TIFFIN

SB-58
Fuel Sending Unit

SB-58 Fuel Sending Unit

PowerGlide Chassis

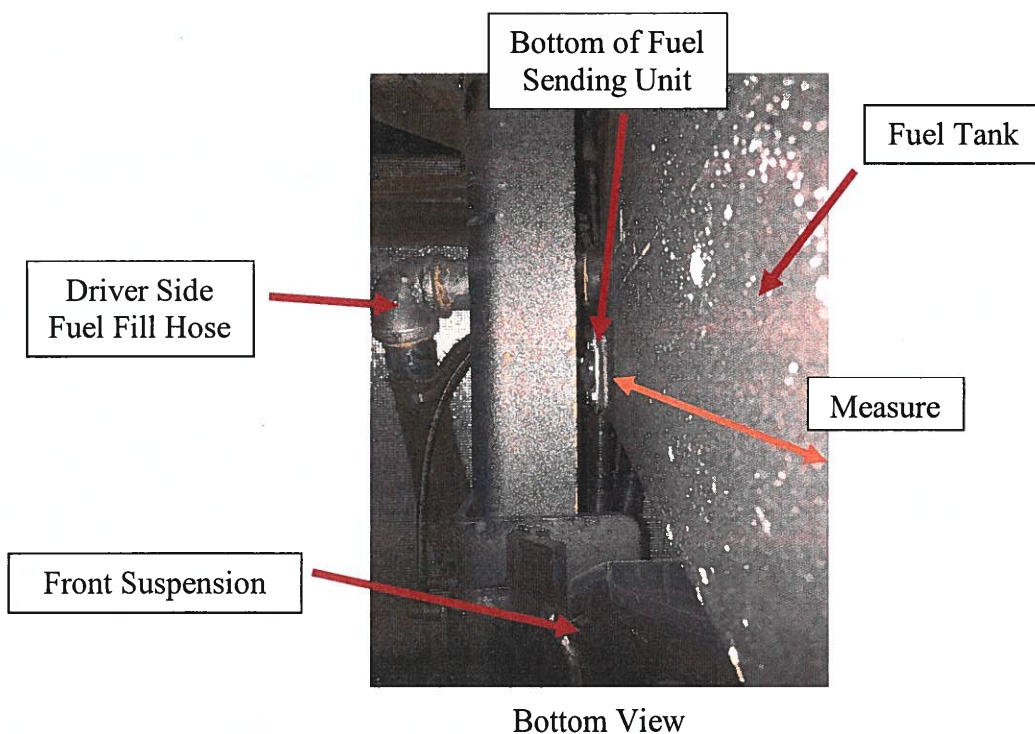
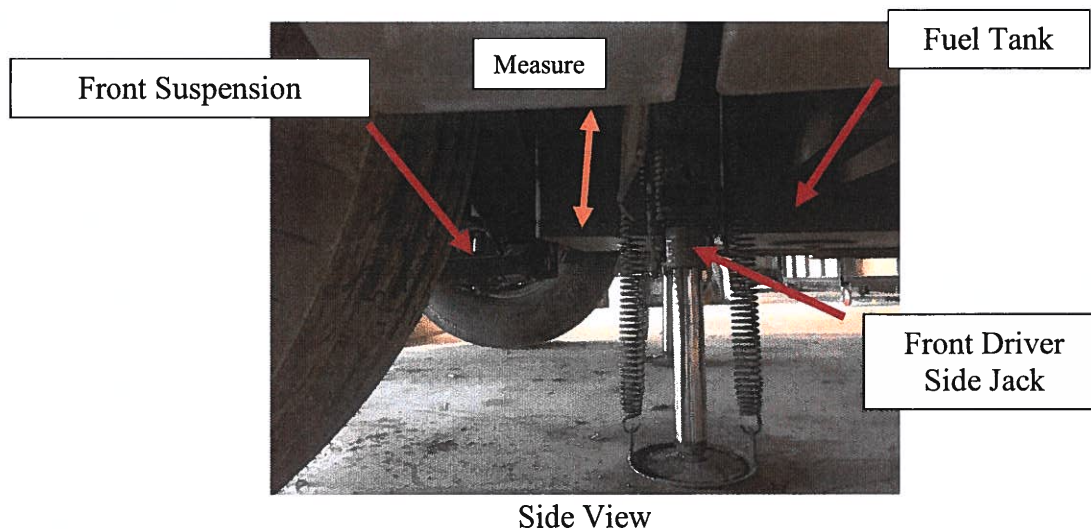
1. Locate the fuel sending unit. It is located on the front driver side of the fuel tank between the jack and the front suspension.

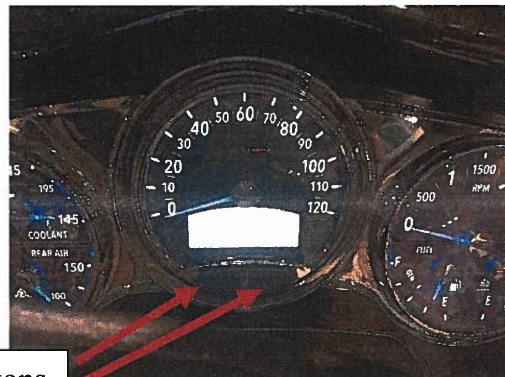
2. Measure from the bottom of the fuel sending unit to the bottom of the fuel tank.

If the length is 14.5 inches, STOP. No further work is necessary. If the length is 17 inches, then continue with steps 3-7.

3. The fuel gauge should read below 3/8 tank before removing the fuel sending unit. Replace the fuel sending unit with Tiffin part no. 5076643. Tighten the four screws to 85 inch-pounds.

Buttons

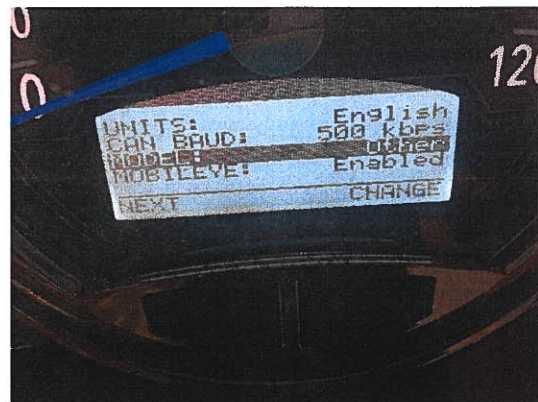
4. Press and hold the two buttons at the base of the speedometer to enter the setup menu.

Setup Menu

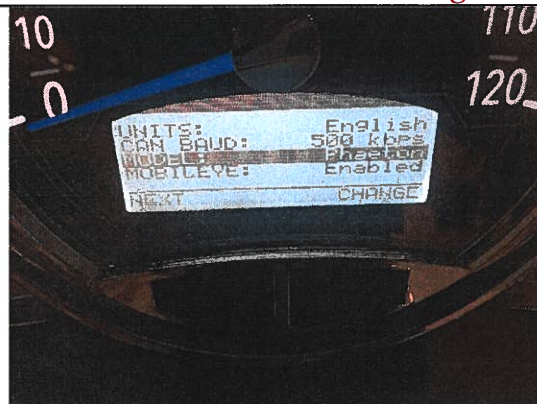
6. Use the right button to cycle through the model options until "Phaeton" is shown.
